E3101A-17

S E R V I C E N O T E

4071A Semiconductor Parametric Tester

Cable Stoppers Prevent to Loosen Extended Path Cable

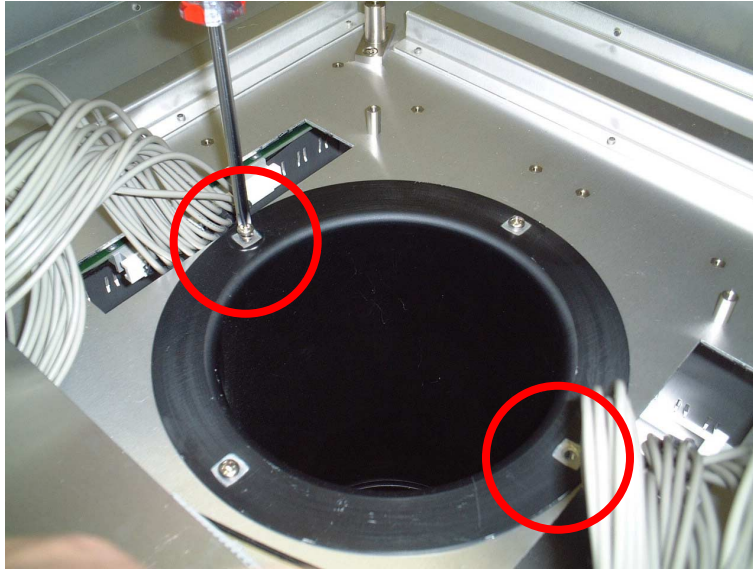
The contact check of PV relay test may fail in some pin boards. Swapping the failed pin board does not move the problem symptom.

The PV relay test fail may be caused by loose extended path cable. Check if the extended path cable is connected tightly. If the extended path cable is loose, attach the cable stoppers to the connection between extended path cables and matrix motherboards.

Cable Stopper

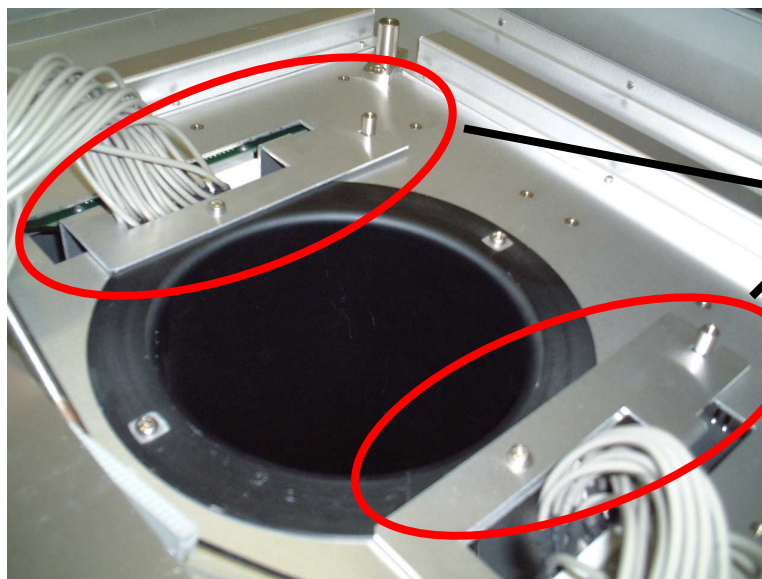
3. Attach the cable stoppers.

4. Screw the cable stoppers by using two screws removed in the step 2.
5. Install the cover.
